AFS-09-0276

**Subject:** RESPONSE TO REQUEST FOR ADDITIONAL INFORMATION DATED JUNE 29, 2009 FOR THE BRR PACKAGE, REVISION 1, DOCKET No. 71-9341

### Docket No. 71-9341, Model No. BRR Package Responses to NRC Request for Additional Information

Figure 1.2-12 – BRR Package Containment Boundary

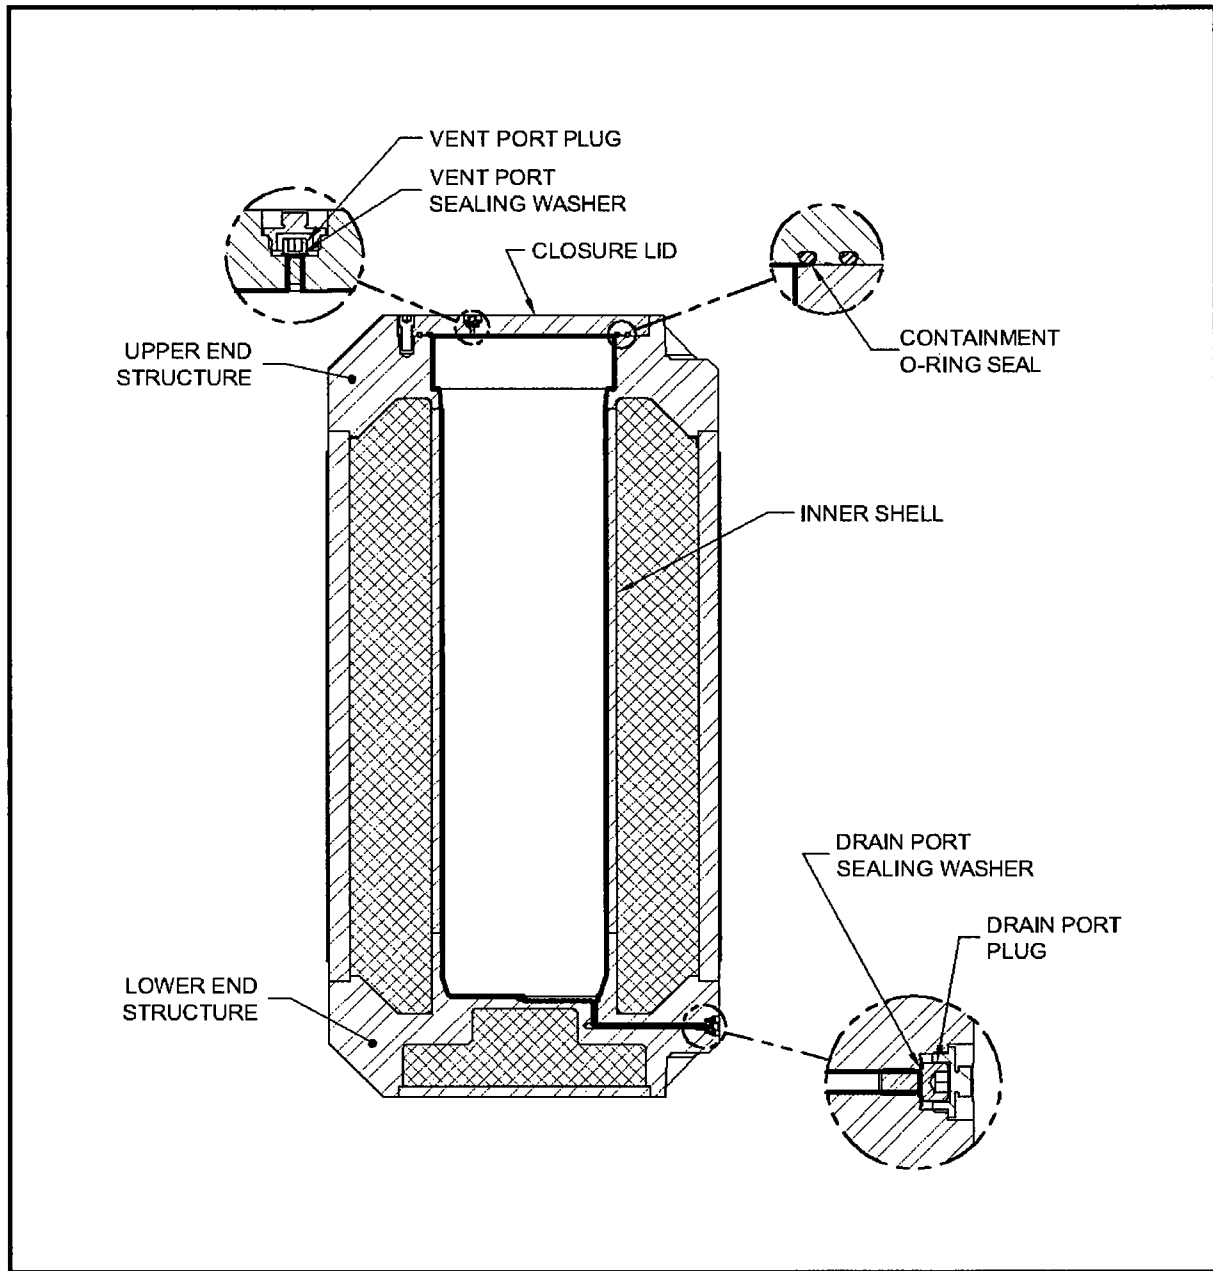
- 1-2 On page 1.2-1 of the application, add description of the package containment boundary to section 1.2.1.1, "Cask Body," by identifying the associated metal structural components that must be evaluated to meet the proposed Category I package fabrication criteria, per NUREG/CR-3854, "Fabrication Criteria for Shipping Containers."

**Response:** A description of the containment boundary has been added to Chapter 1 in Section 1.2.1.1, including Figure 1.2-12. This information is also found in Section 4.1.1.

Figure 2.12.5-2 - Dimensions Used in CASKDROP

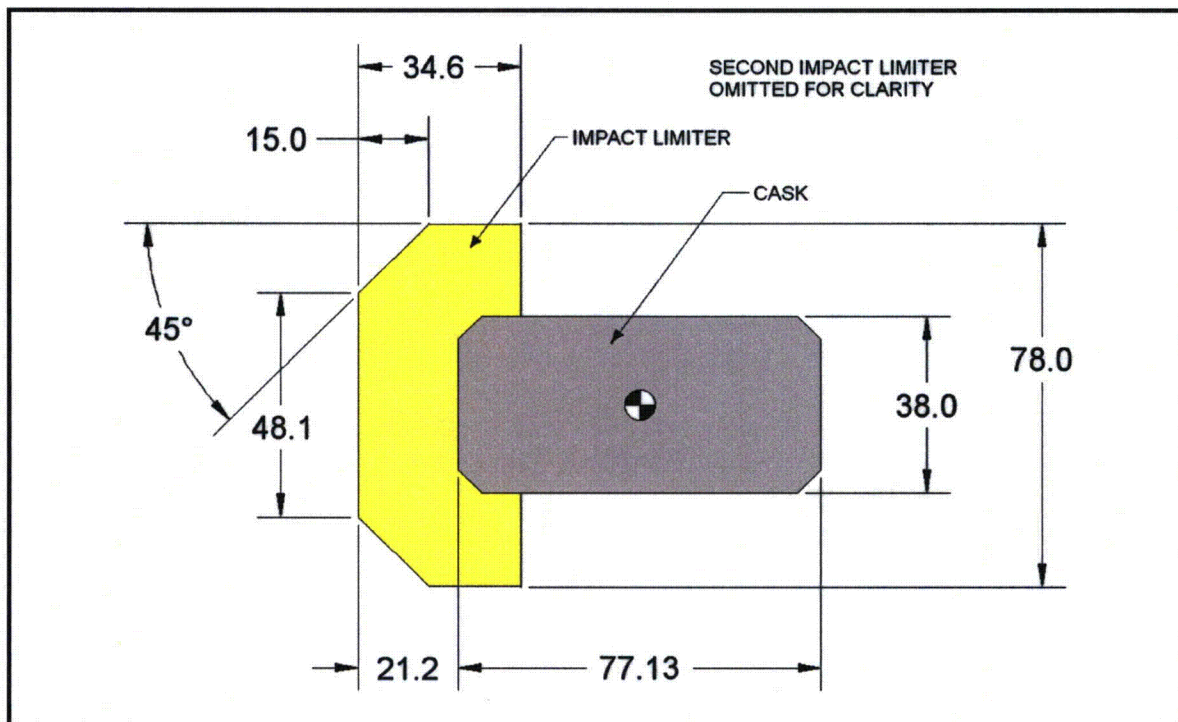
The force-deflection curves are misleading, considering the geometry and dimensions, in Figure 2.12.5-2, for the impact limiter CASKDROP analysis. The force-deflection curves in all cases are shown to be applicable for "deflection" levels up to 100%, which is physically unattainable.

Figure 3.5-14 – Convection Coefficient Variation During HAC Transient

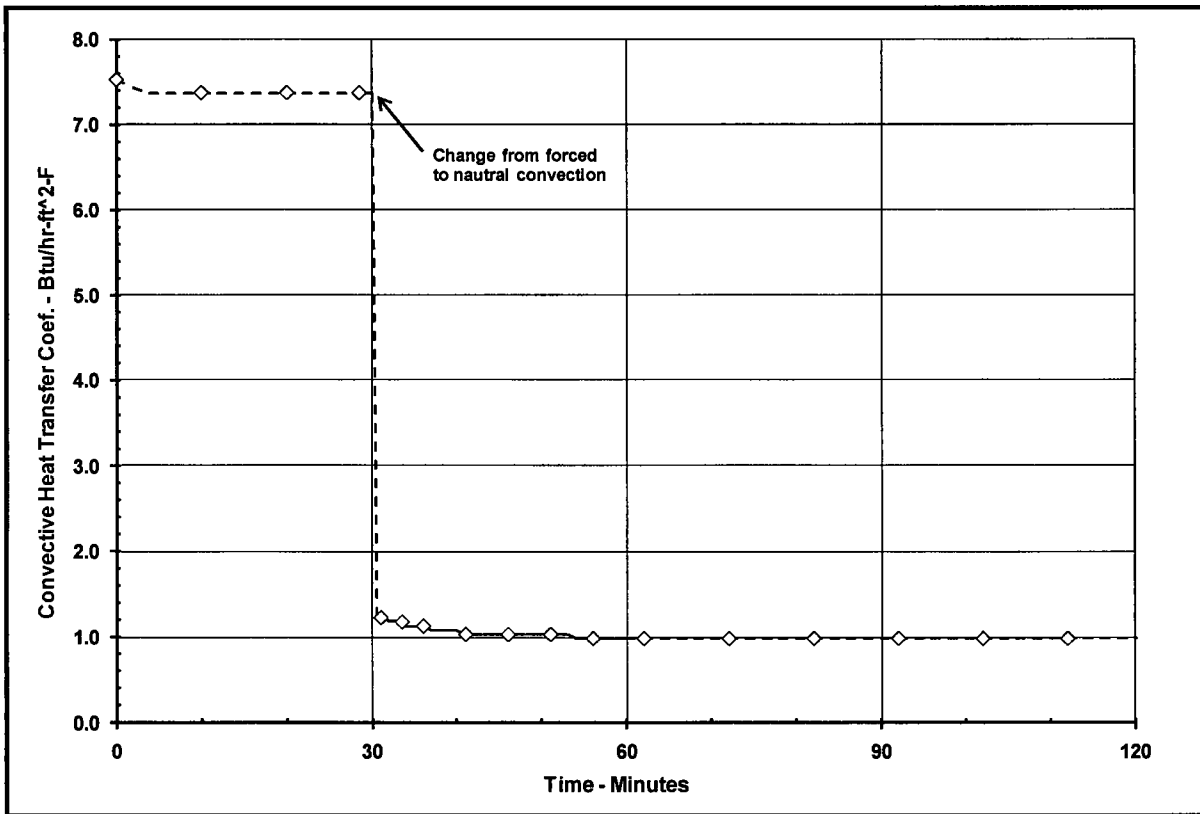
- 3-2 Verify the convection heat transfer coefficient used for the analysis of the 30-minute fire by comparing to previously accepted values obtained from reliable reports such as "Thermal Measurements in a Series of Large Pool Fires," Sandia Report SAND85 –0196 TTC – 0659 UC 71, (August 1971)."

Section 3.4.2 of the application states the convection heat transfer coefficients between the package and the ambient during the 30-minute fire event are based on an average gas velocity of 10 m/sec. The actual convection heat transfer coefficient used during the analysis is not provided in the application. Typical values obtained from measurements reported on the above Sandia report are on the order of 4.5 BTU/ft<sup>2</sup>-h-°F). The applicant should verify the convection heat transfer coefficient used during the 30-minute fire analysis of the BRR package is on the order of this value.

**Response:** As documented in Chapter 3.0, the convection heat transfer coefficients between the package and the ambient are not defined as a fixed number, but are continuously re-computed during the HAC transient based on the mean gas temperature. The variation in the computed convection coefficient with time is shown below for the first 120 minutes of the HAC transient. As seen, the convection heat transfer coefficient is approximately 7.4 BTU/ft<sup>2</sup>-h-°F during the fire portion of the transient and then drops to approximately 1.0 BTU/ft<sup>2</sup>-h-°F during the initial phase of the package cool-down. The predicted heat transfer coefficient is approximately 60% higher

The figure below is provided as Figure 3.5 14 in the revised SAR text.
